TO: ALL TRIUMPH DEALERS - WESTERN ZONE

DEPT: SERVICE AND PARTS DEPARTMENTS

SUBJECT: SPITFIRE SPEEDOMETER CABLE RUN

BULLETIN T-67-1
(Re-issue of T-64-1)

FIG. 1

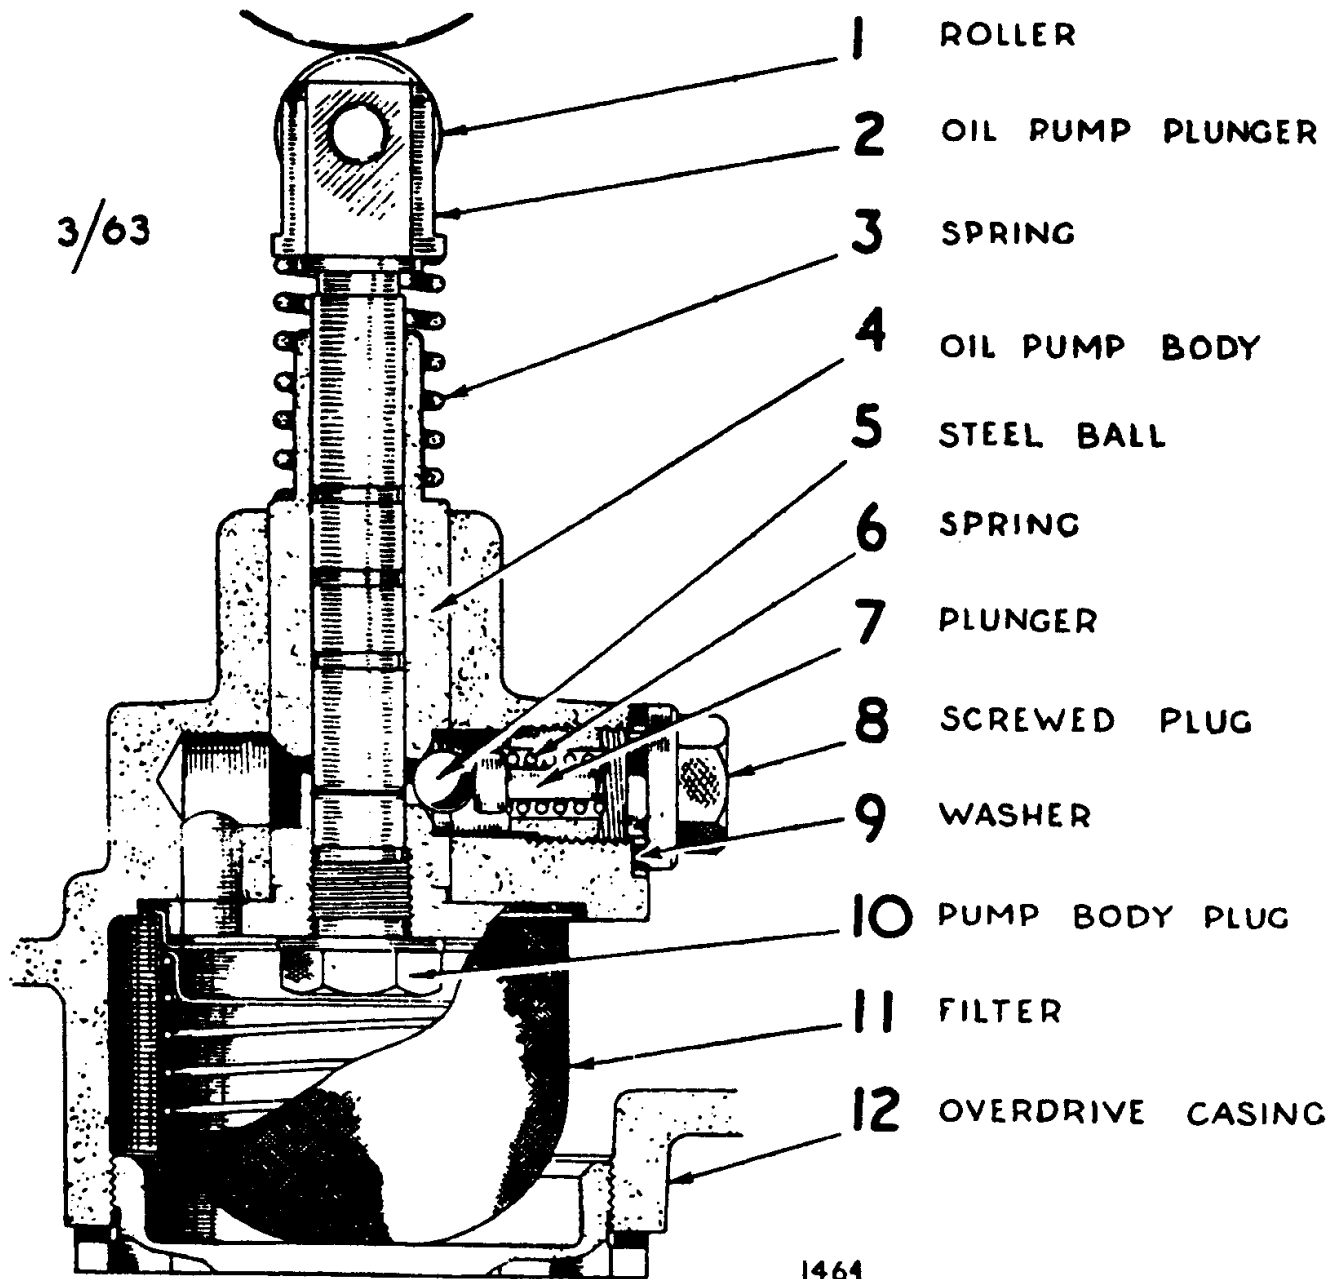
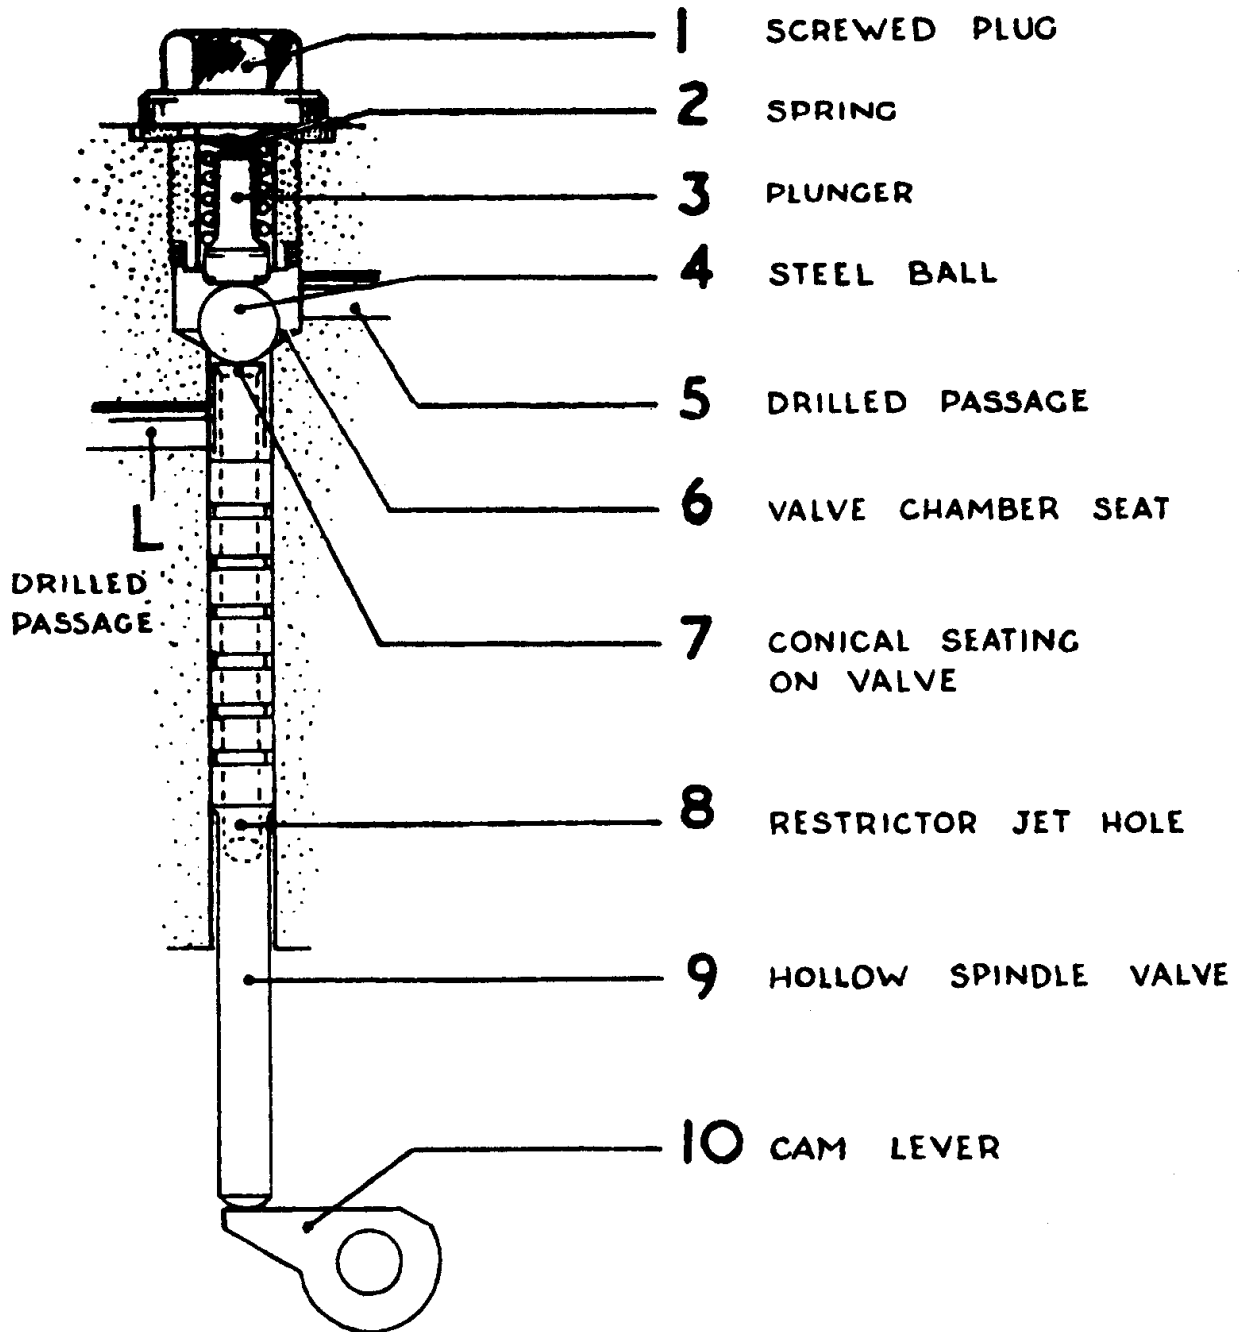
For adjusting the solenoid on "D" type see Service Bulletin 1-63-60. PUMP NON-RETURN VALVE (Figure 1)

In "A" type units access to the valve necessitates removal of the solenoid and solenoid bracket. The bracket is secured by two 5/16" (7.937 mm.) diameter studs and two t/16" (7.937 mm.) diameter bolts, the head of the bolts being painted RED. THE NUTS MUST BE REMOVED FROM THE STUDS BEFORE TOUCHING THE BOLTS. The two bolts should not be slackened off together releasing the compression on the accumulator spring which abuts the solenoid bracket.

After removing the valve plug, spring, plunger and ball, clean the seat and reset the ball by giving it a sharp tap with a suitable hammer and drift.

T-67-14

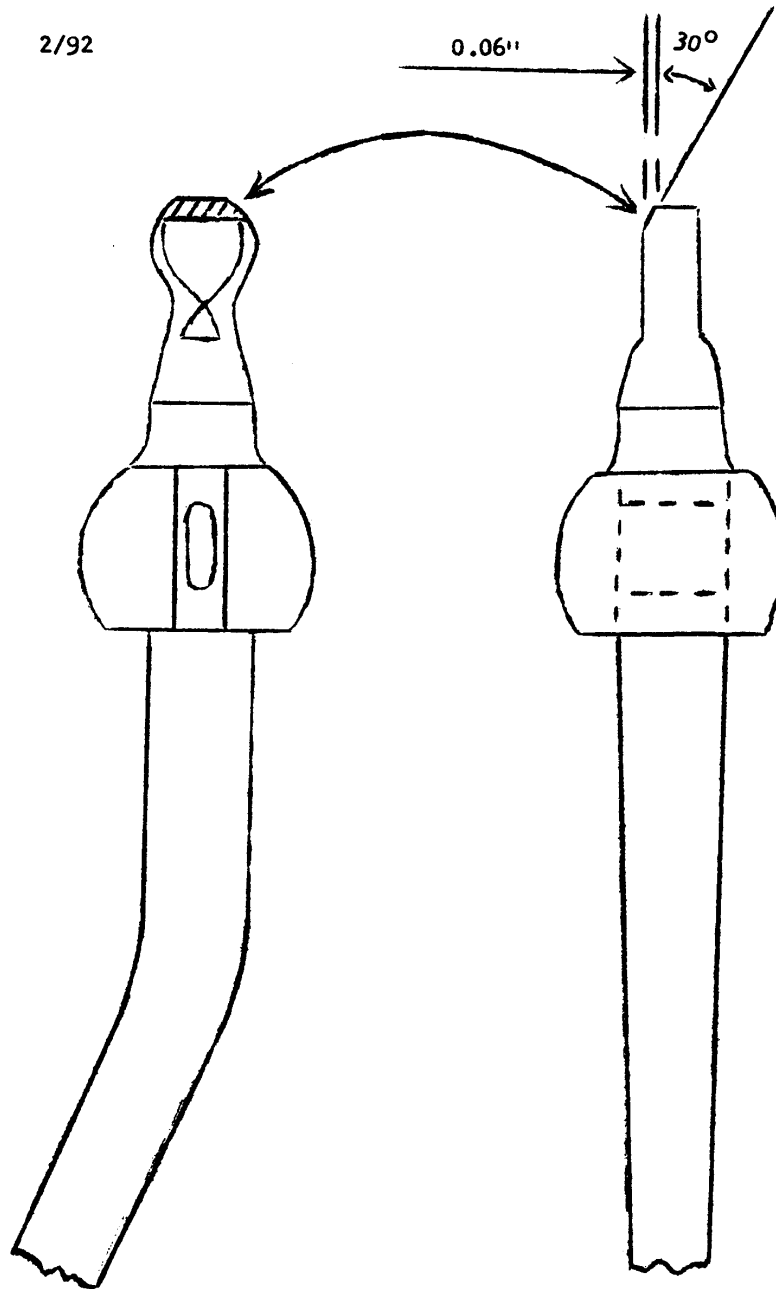
- (c) Grind a small 30° chamfer on the side of the ball end of the gear lever adjacent to the reverse selector.. This is necessary to assist the "knock over" action. (See illustration attached)
- (d) Lubricate and assemble all parts, but replace the original gear lever spring with the heavier type, part number 145472. Ensure that the small plunger and spring in the ball end of the lever do not become displaced on assembly.
